UNITED STATES PATENT AND TRADEMARK OFFICE

10/724,262

Office Action Summary

DETAILED ACTION

FIG. 20A

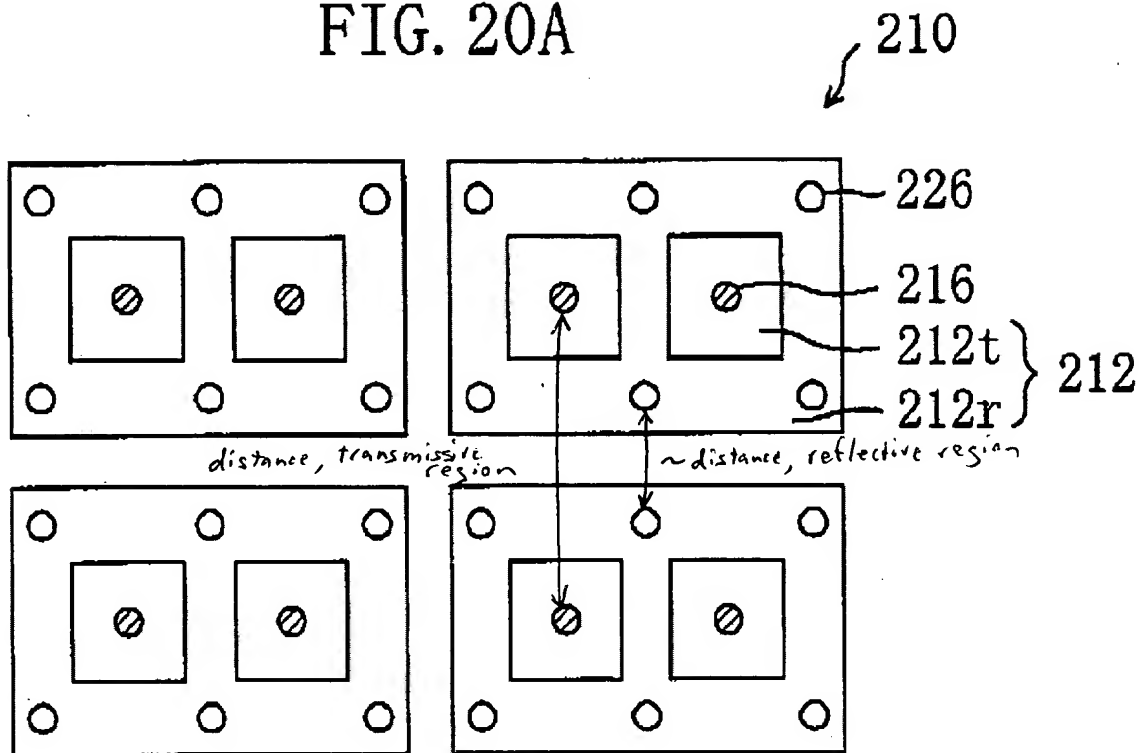
a plurality of alignment controlling elements (Figures 18A and 18B elements 216 and 226) controlling the alignment of the liquid crystal in each of the transmissive display region and the reflective display region, the alignment controlling elements provided on the electrode of at least one of the pair of substrates, the occupying area of the alignment controlling elements in a plane direction of the substrate being set larger in the reflective display region than in the transmissive display region (Figures 18A and 18B), the distance between adjacent two of the alignment controlling elements arranged in the reflective display region being smaller than the distance between adjacent two of the alignment controlling elements arranged in the transmissive display region (Figure 20A, vertical direction).

distance between adjacent two of the openings and/or protrusions arranged in the transmissive display regions (Figure 20A, vertical direction).

FIG. 54

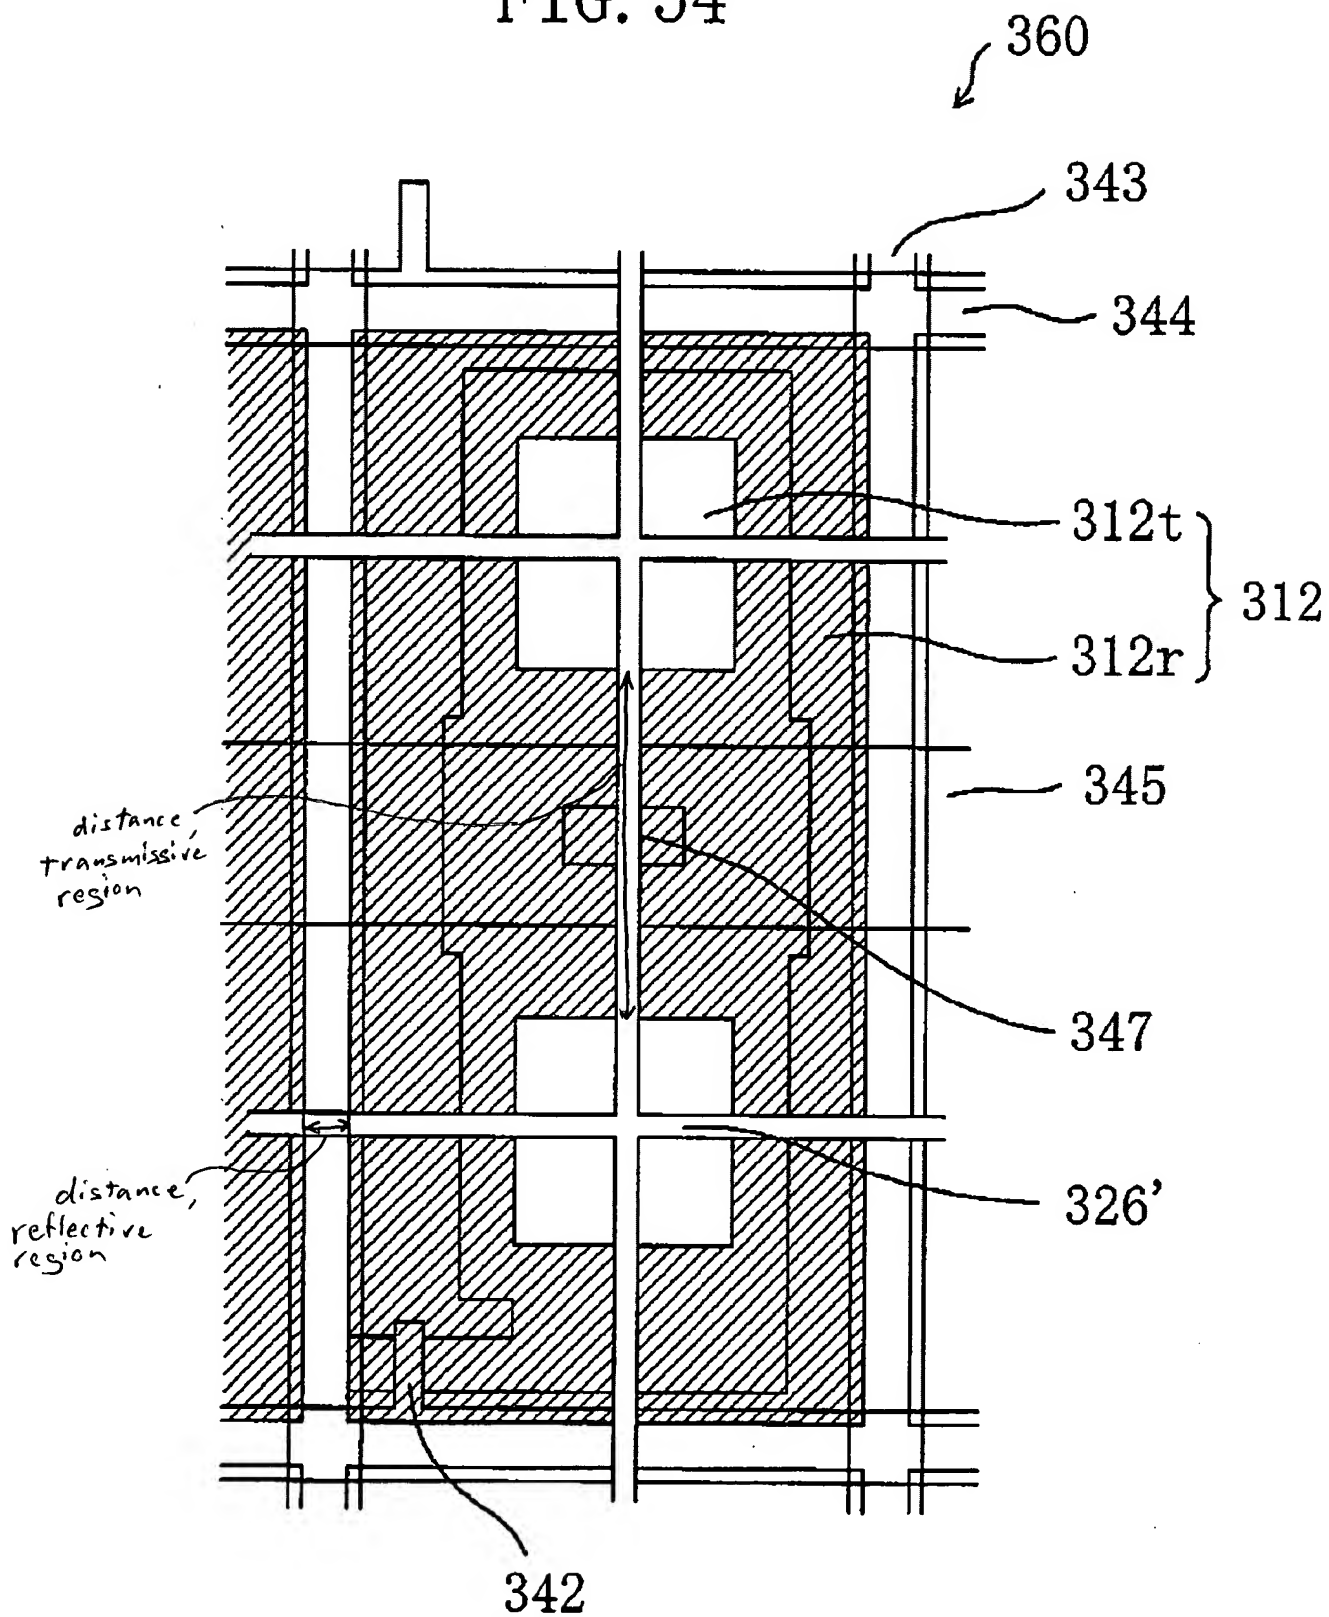
Ogishima fails to explicitly disclose the occupying area of the alignment controlling elements in a plane direction of the substrate as being set larger in the reflective display region than in the transmissive display region. Ogishima discloses a variety of embodiments such as in Figure 54, which show linear alignment controlling elements in both the transmissive and reflective display regions. Kubo teaches increasing the area percentage of the reflective region to transmissive region to up to 90% in an analogous transfective display as an optimization of the display such as for use outdoors and to lengthen battery life (Column 29 line 64 – Column 30 line 22).

Regarding claims 4, 10, 13-15, and 18, Ogishima discloses the distance between adjacent two of the openings and/or protrusions arranged in the reflective display region as being smaller than the distance between adjacent two of the openings and/or protrusions arranged in the transmissive display regions (Figure 54, distance between horizontally adjacent protrusions between reflective display dot regions are smaller than distance between vertically adjacent protrusions in transmissive region, see Figure below).
